# MEETING AGENDAThe Town of RidgelandPLANNING COMMISSIONTuesday, June 21, 2022, 5:30 P.M.Town Hall, Council Chambers, 1 Town Hall, Ridgeland, SC 29936

## WARRENT AND VARIANCE REQUEST NARRATIVE

#### Mungo Homes (Grays Hwy) Preliminary Site Review (03/04/2022)

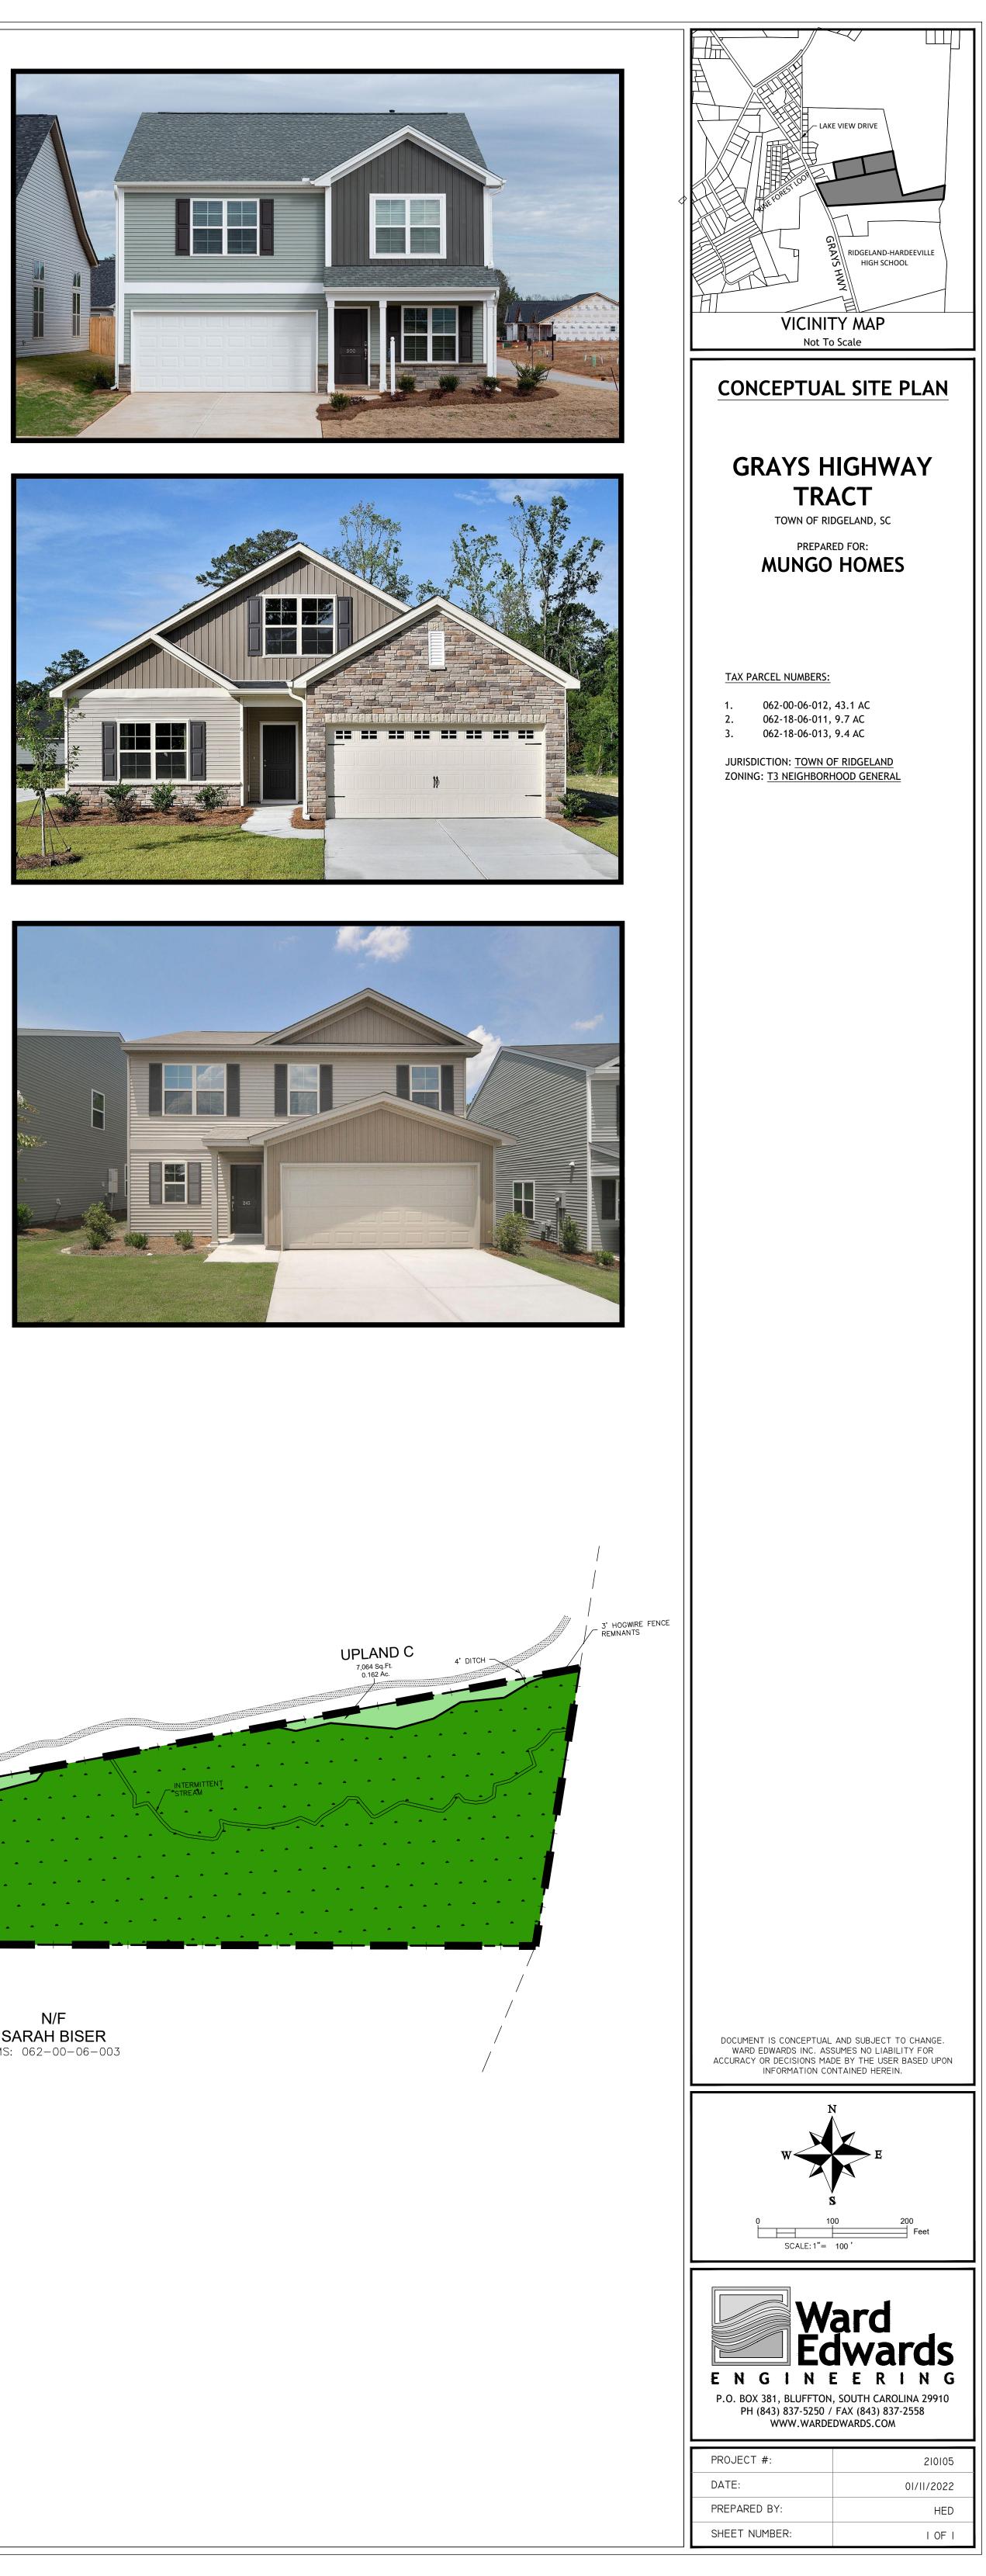
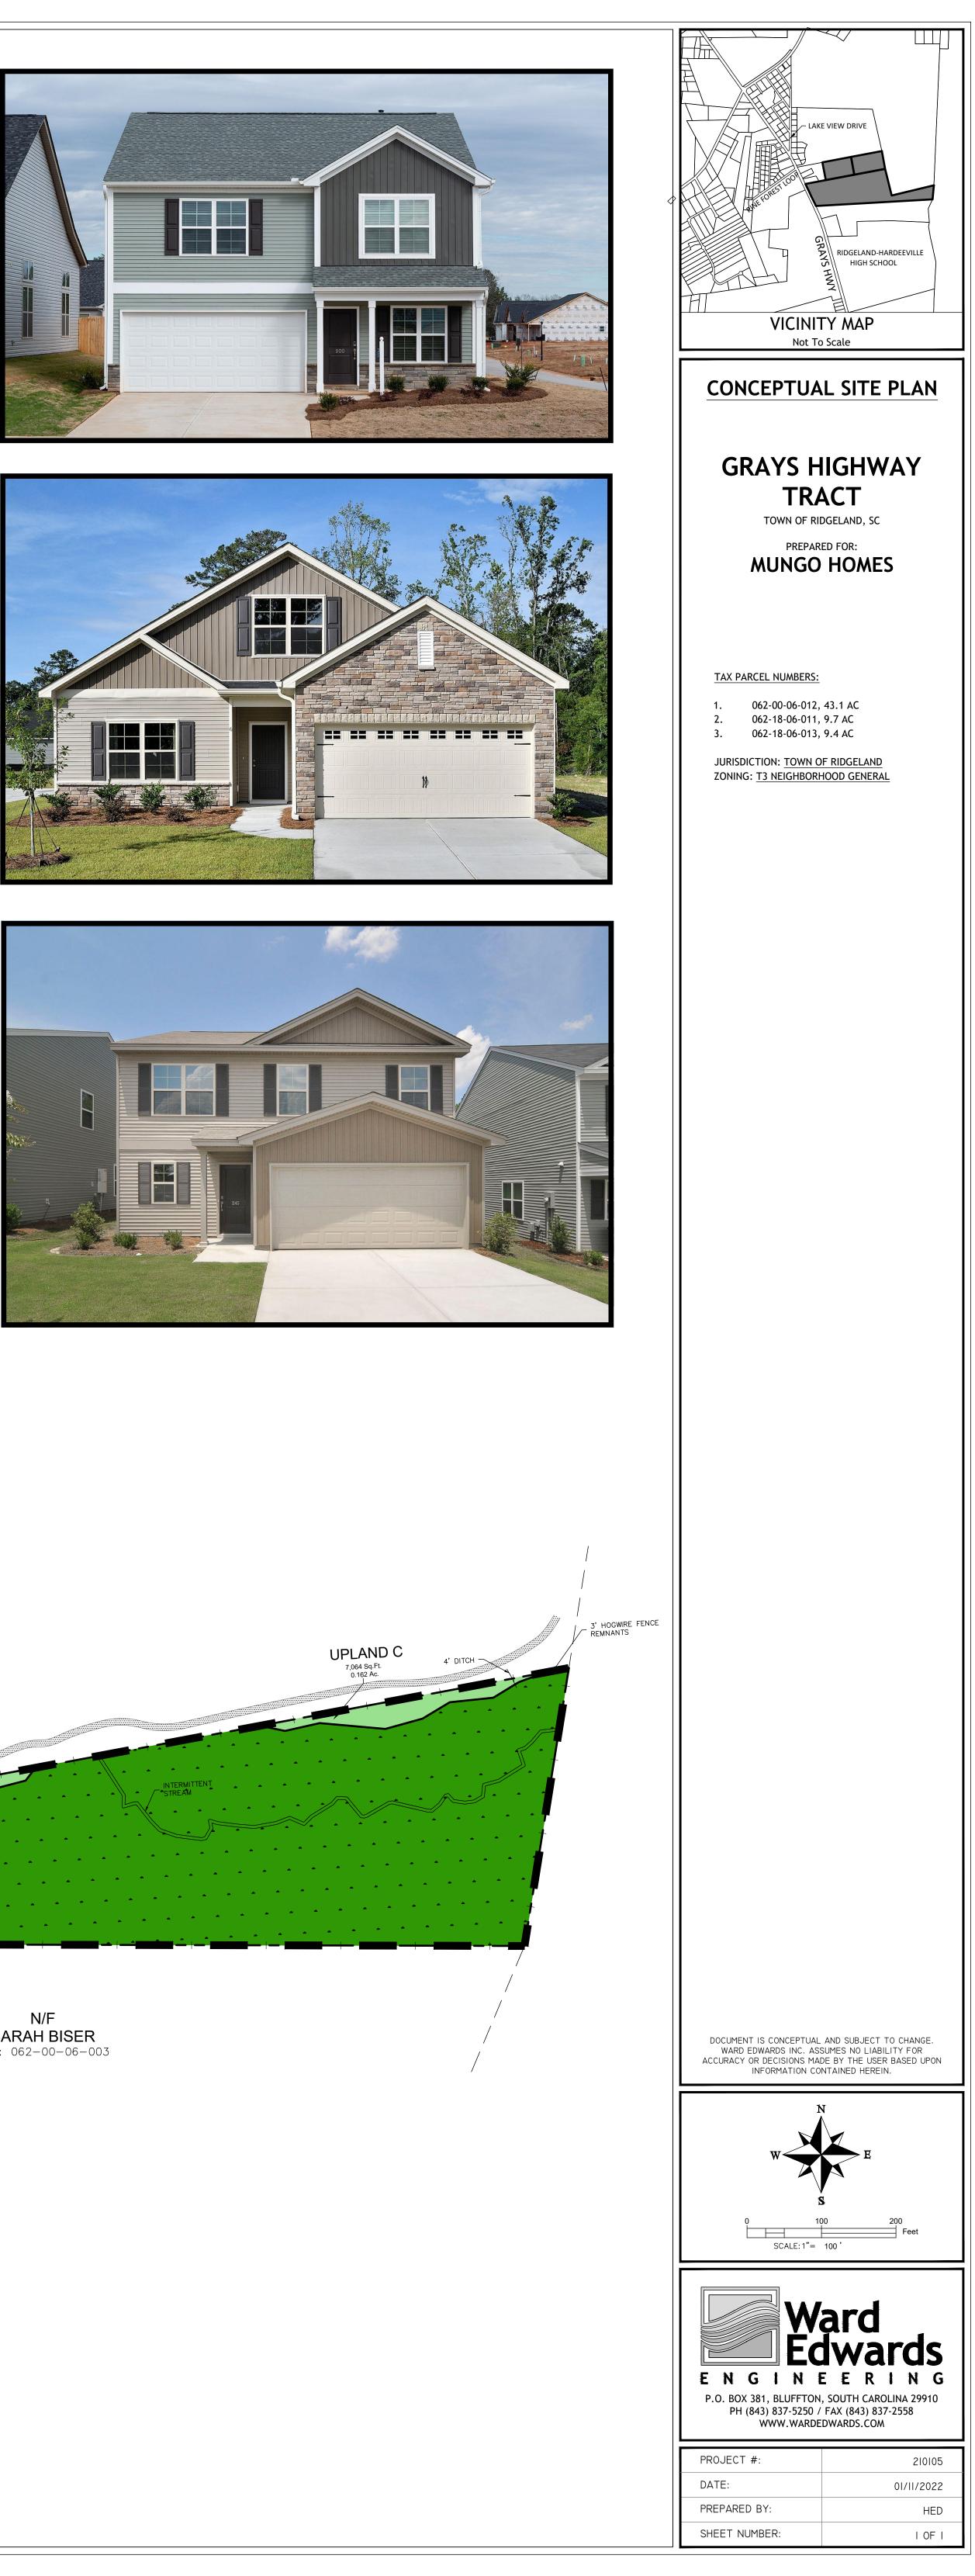
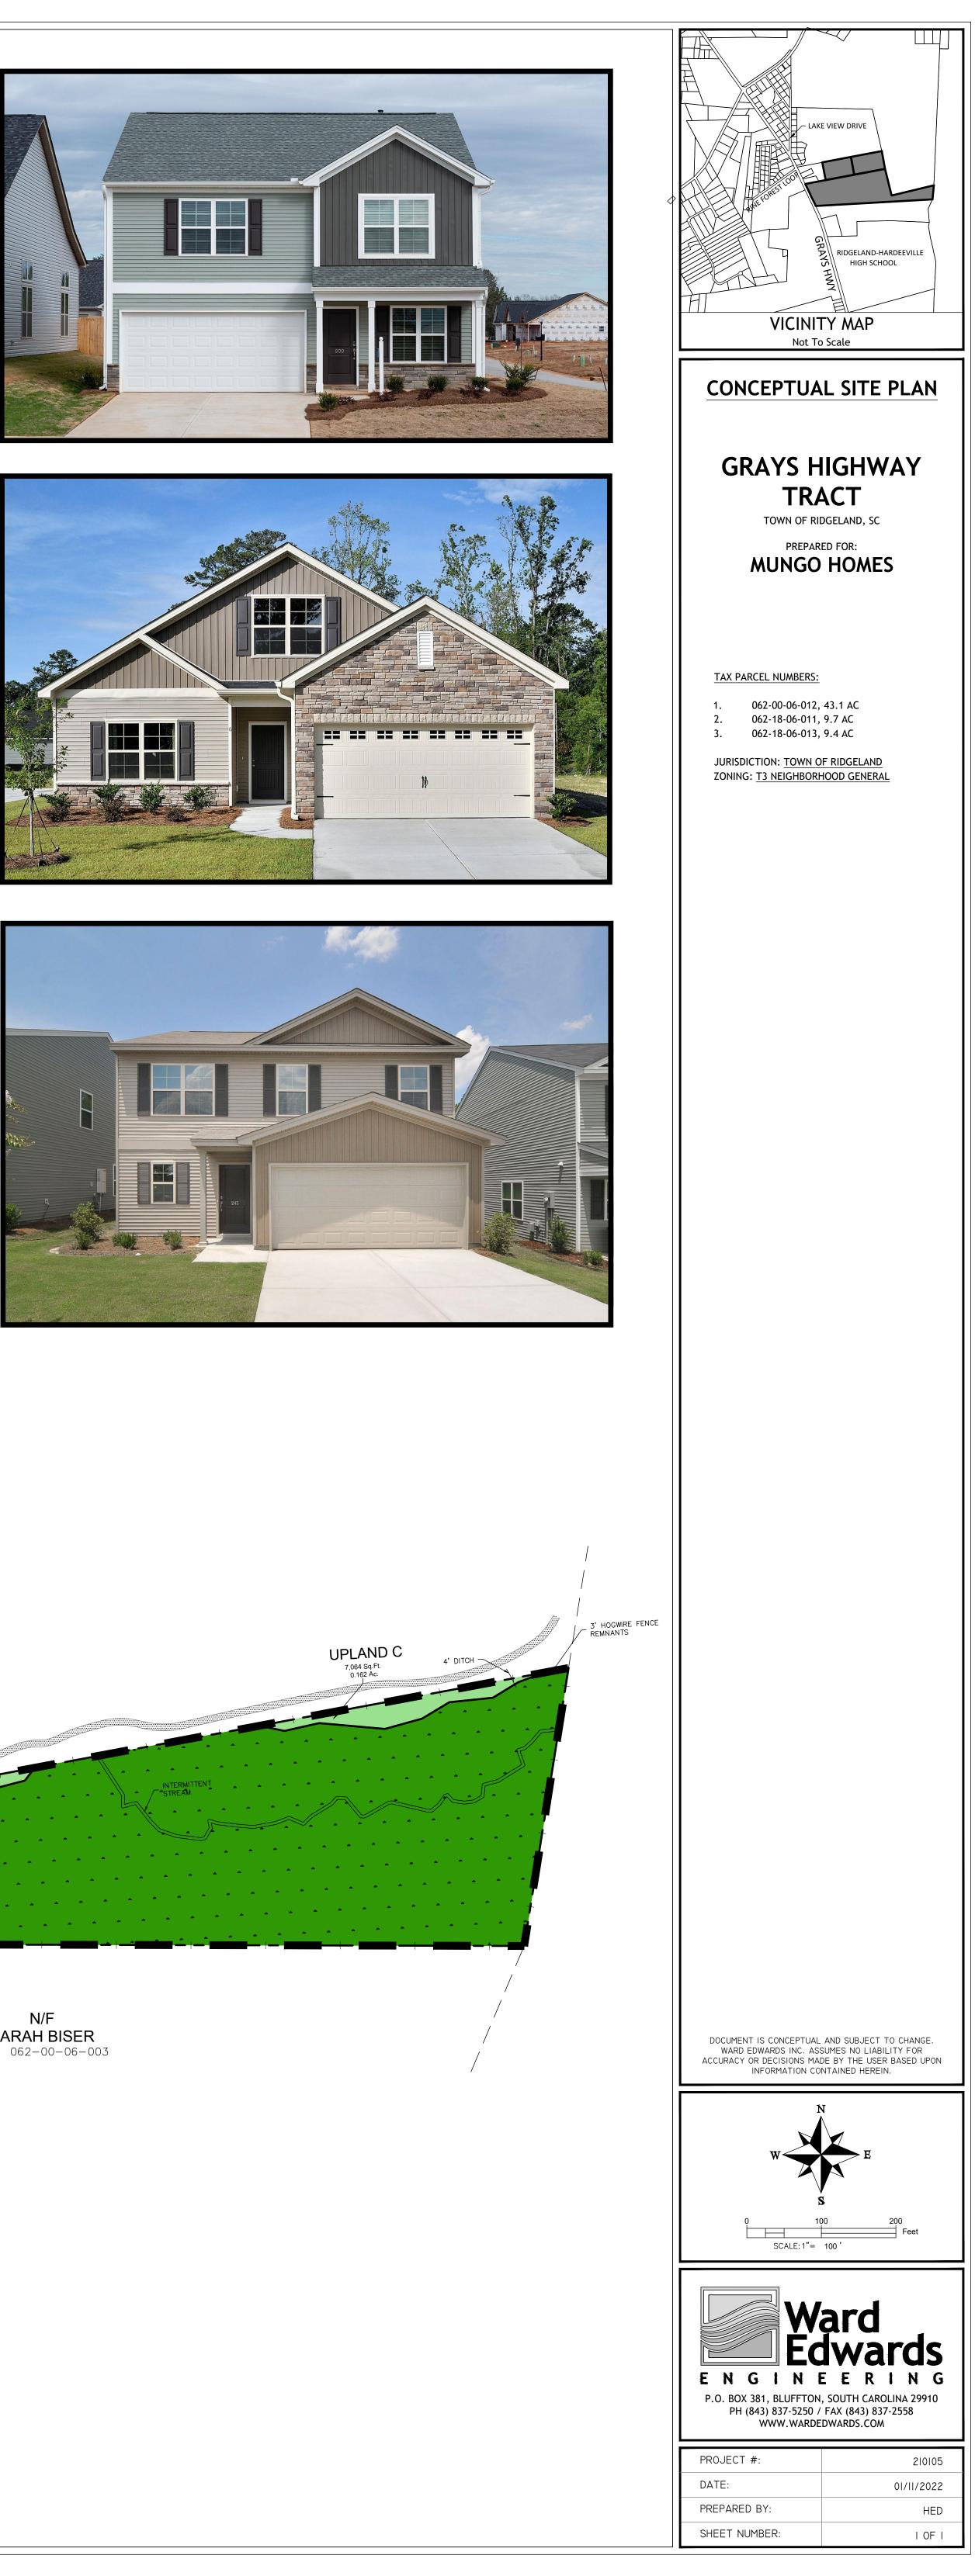
The proposed layout meets minimum sidewalk width of 4-feet. Sufficient roadway width is proposed (24-feet) for two-way traffic. I recommend the engineers review the proposed raised curb for compliance with Table 3B. Does the developer anticipate individual home trash pickup of a centralized garbage collection area? The reason I ask is they seem to be proposing a centralized mail kiosk.

While there is considerable greenspace/open space due to the airport overlay and existing wetland, it is recommended the development designate space on the plan for neighborhood recreation activities. Sufficient square footage exists at the rear of the T3 lots to accommodate this.

Sidewalks/walkways should then continue around T3 block to access the greenspace
